JOCPROJ -South Texas ISD SCI CTE Automotive Expansion 2025

Addendum #1

ADDENDUM NO. 1

A. PURPOSE AND INTENT
This addendum is issued for the purpose of modifying the plans and specifications for the *JOCPROJ - South Texas ISD SCI CTE Automotive Expansion 2025.*

A2.03

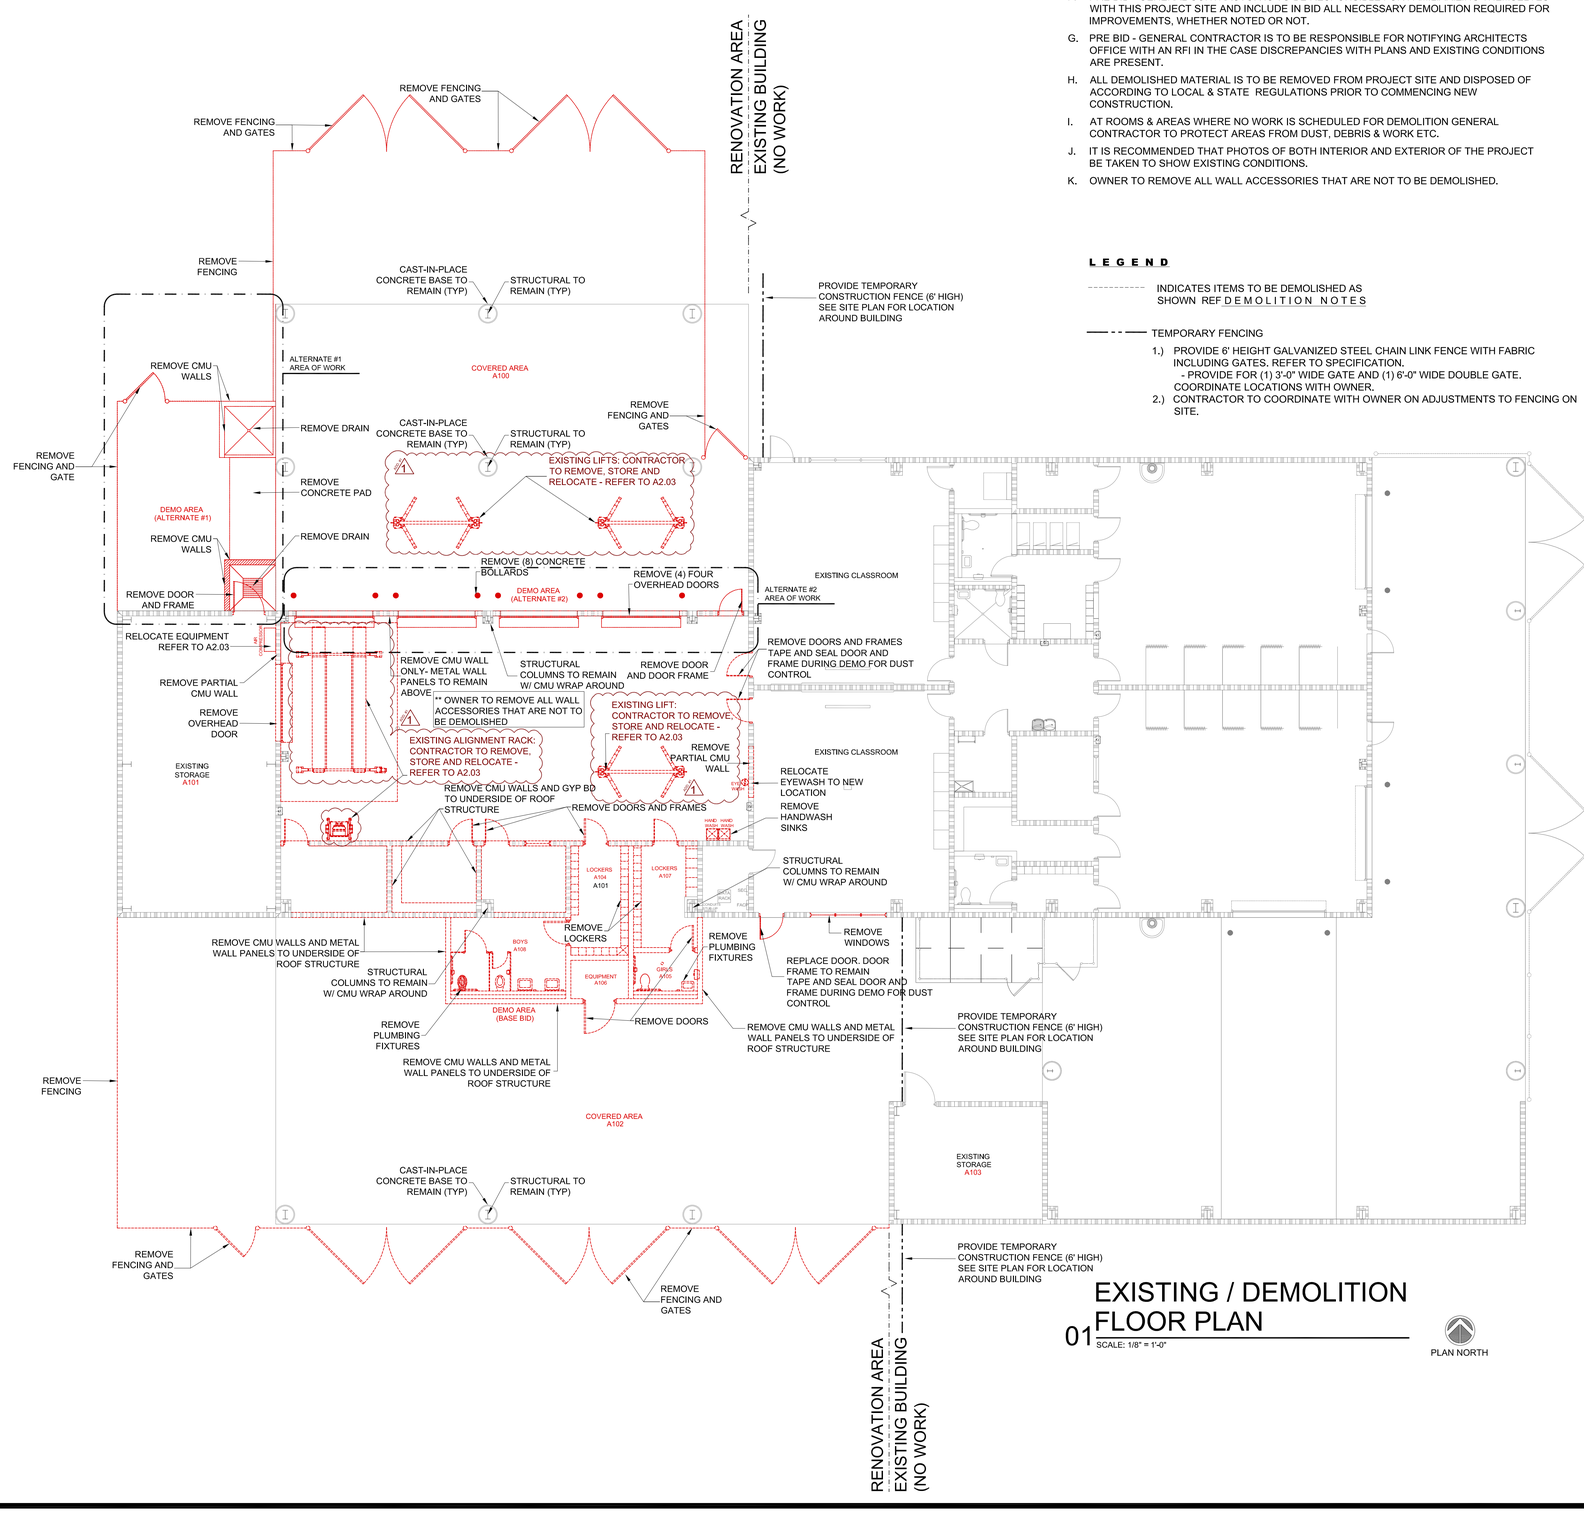
A2.03 – Proposed Equipment Plan and Schedule

- Revised Notes on Equipment Plan

1 -EXISTING LIFTS SHALL BE REMOVED AND RELOCATED AT SAME LOCATION (ALT#2)

2 -EXISTING ALIGNMENT RACK TO BE REMOVED AND RELOCATED AT NEW LOCATION (BASE BID)

3 -EXISTING LIFT TO BE REMOVED AND RELOCATED AT NEW LOCATION (BASE BID)

GENERAL CONTRACTOR SHALL VERIFY EQUIPMENT IS OPERATIONAL BEFORE REMOVING AND AFTER REINSTALLATION.
A PRE FUNCTIONAL TEST MEETING IS REQUIRED BETWEEN OWNER AND CONTRACTOR PRIOR TO EQUIPMENT REMOVAL

LIFTS AND ALIGNMENT RACK SHALL BE STORED IN A SAFE CONTAINER PRIOR TO REINSTALLING

D2.01

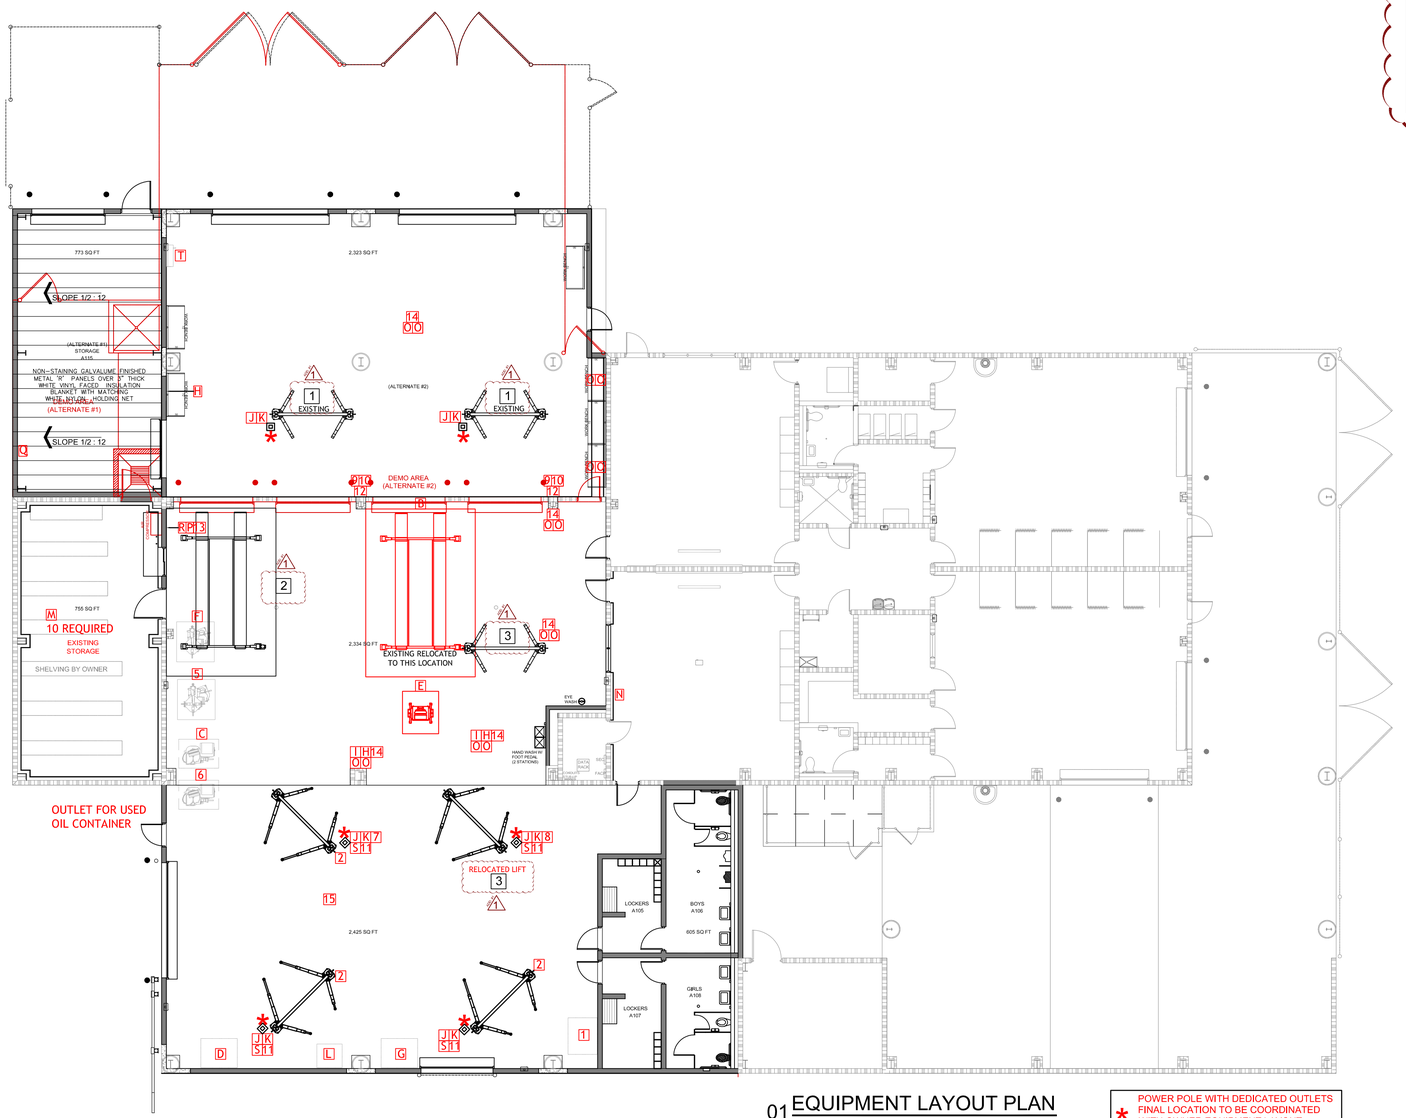
D2.01 – Existing / Demolition Floor Plan

- Existing Lifts and Alignment Rack to be removed, stored and relocated by Contractor.

A5.01

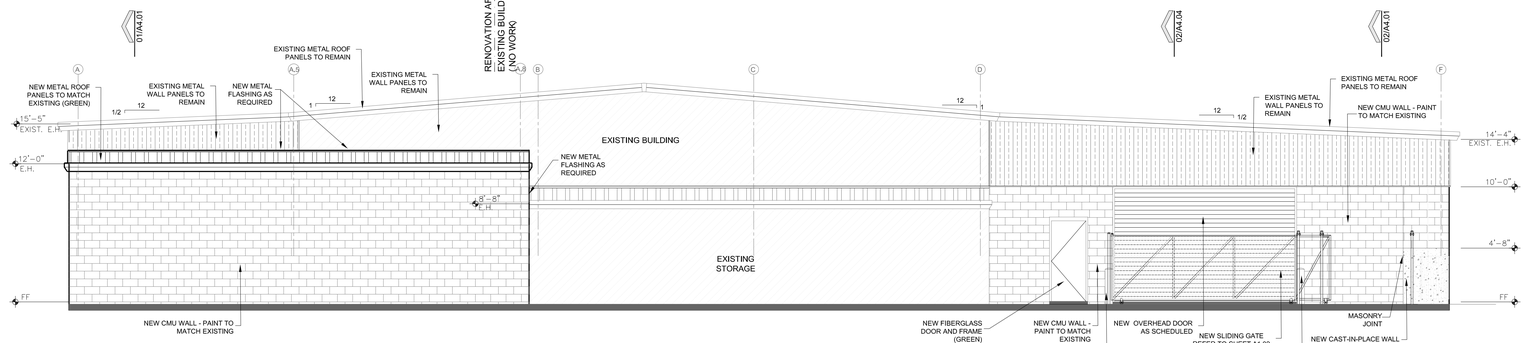
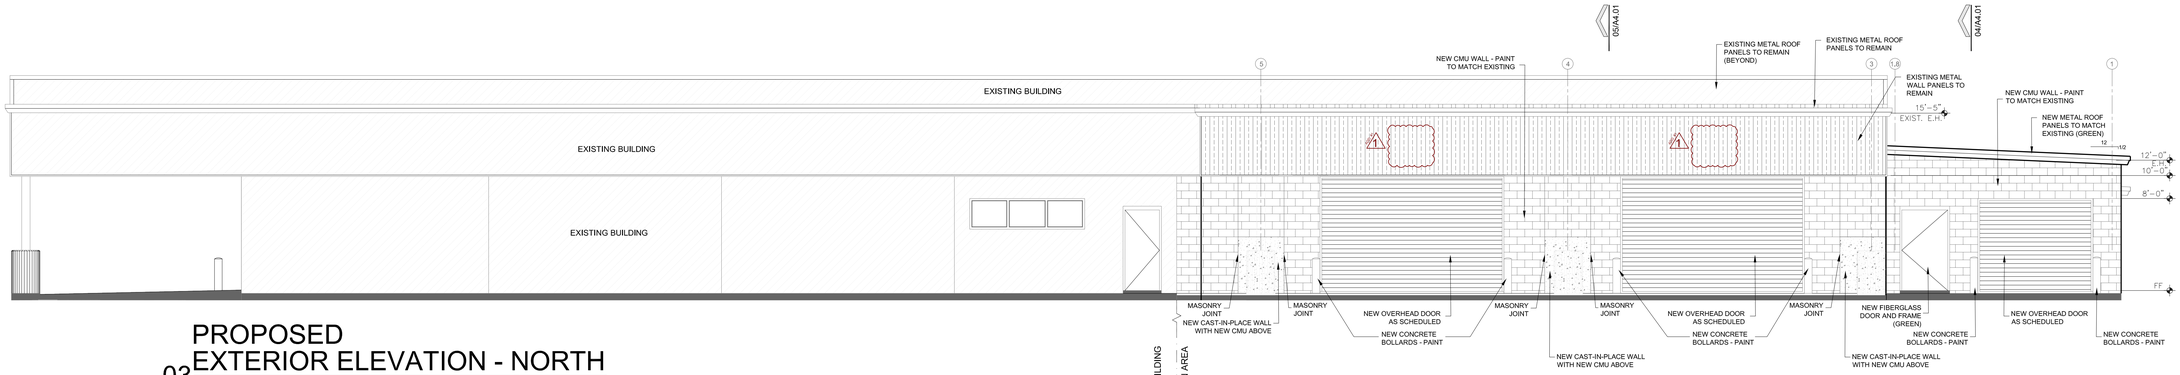
A5.01 – Exterior Elevations

- Provide Louver locations.
- Color selection to Match Existing Metal Panel.

Date: 03/21/2025
Scale: As Noted
Project Architect: David Monreal, AIA
Drawn By: B.B.
Job No. 25v22
Sheet: M3.01

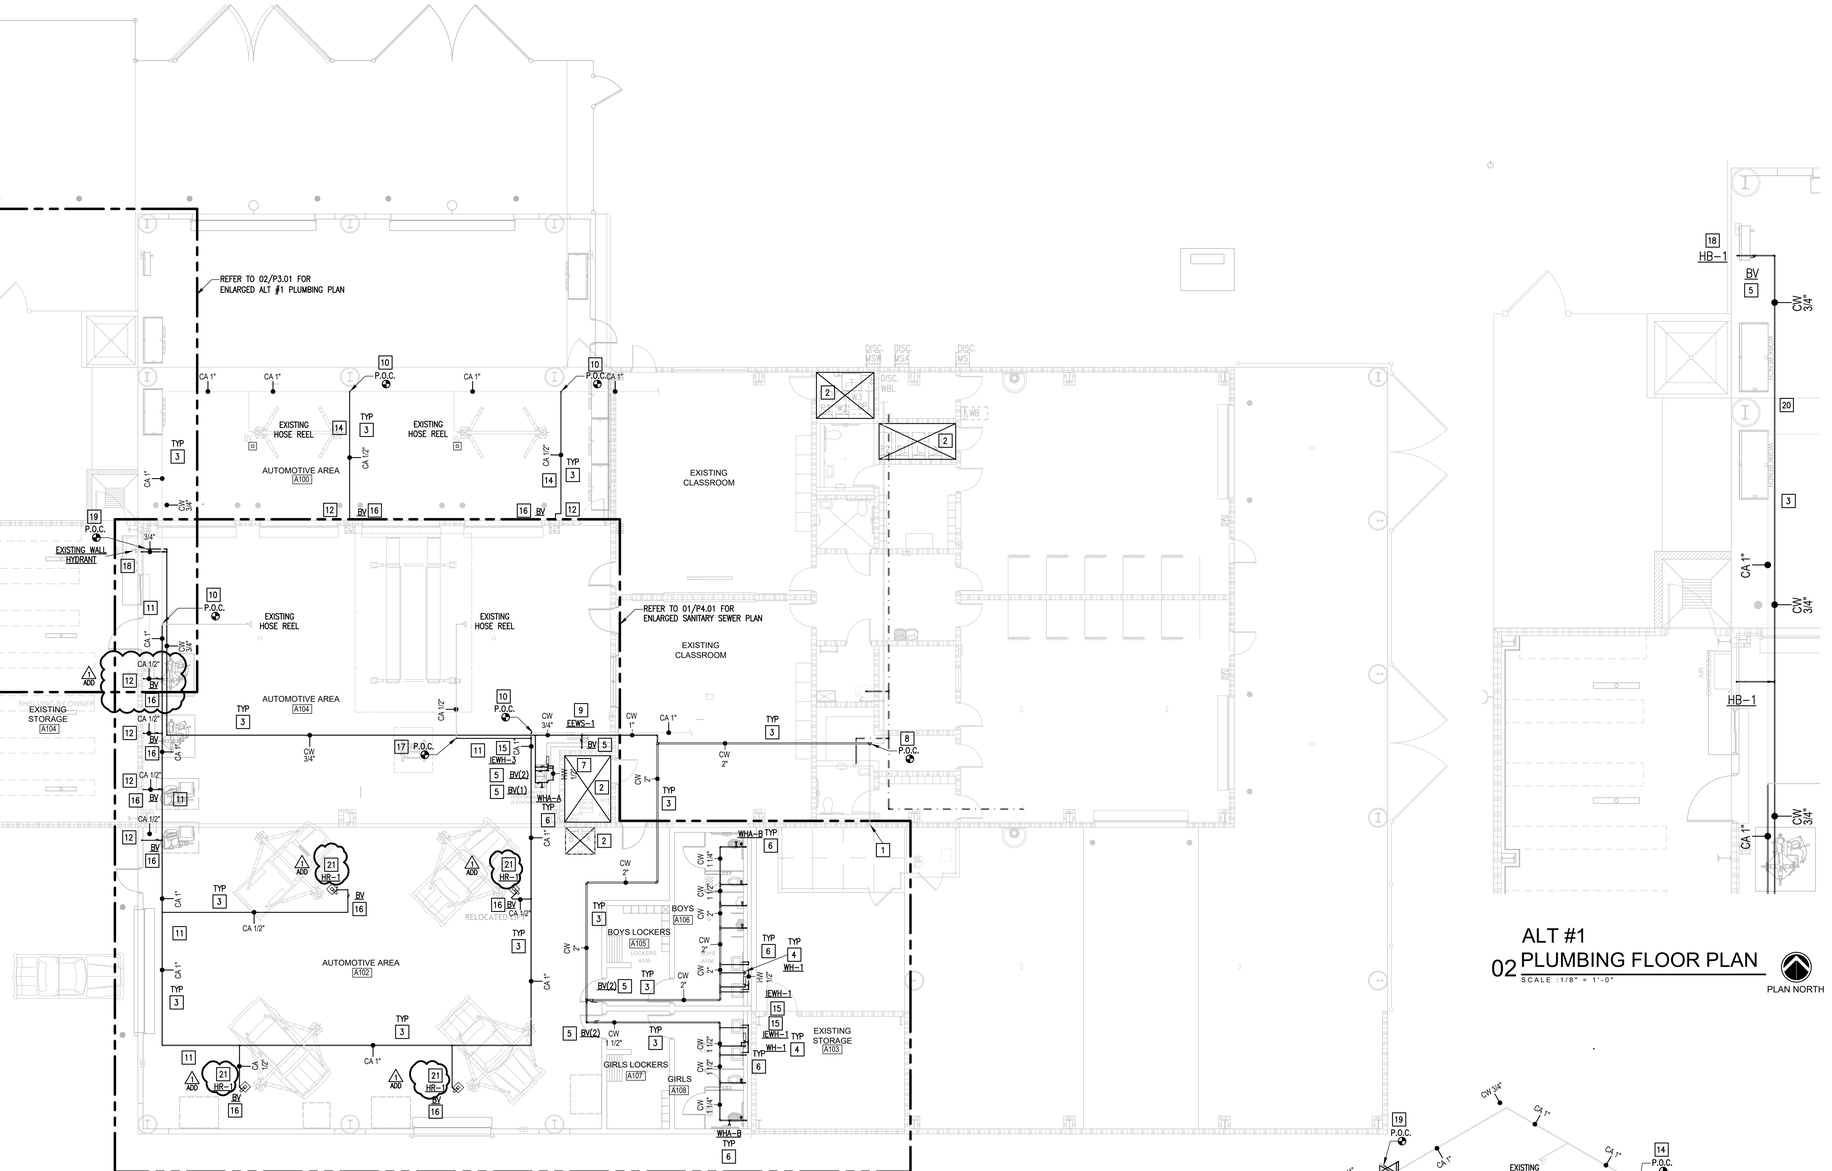
1. M3.01:
    a. Added louver height to EAL-1. See attached sheet.

Date: 03/21/2025
Scale: As Noted
Project Architect: David Monreal, AIA
Drawn By: MOV
Job No. 25v22
Sheet: P3.01

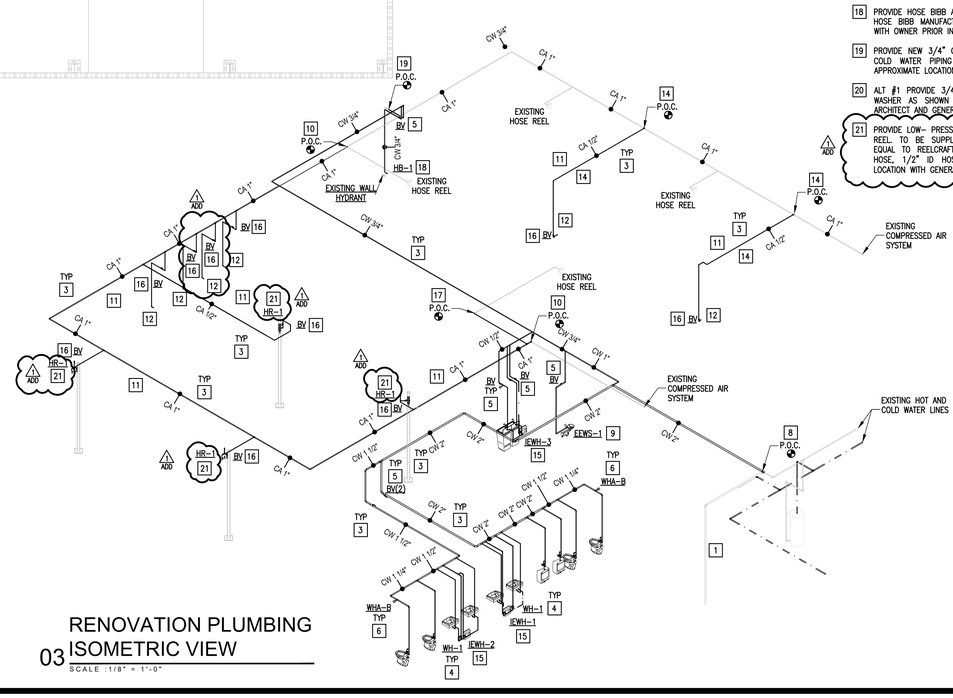
2. P3.01:
    a. Revise Plumbing Floor Plan. See attached sheet.
    b. Revised Plumbing Keynotes.

Date: 03/21/2025
Scale: As Noted
Project Architect: David Monreal, AIA
Drawn By: MOV
Job No. 25v22
Sheet: P5.01

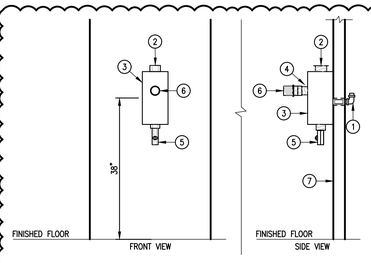
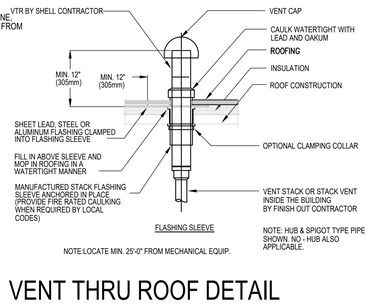
3. P5.01:
    a. Revise Plumbing Details. See attached sheet.
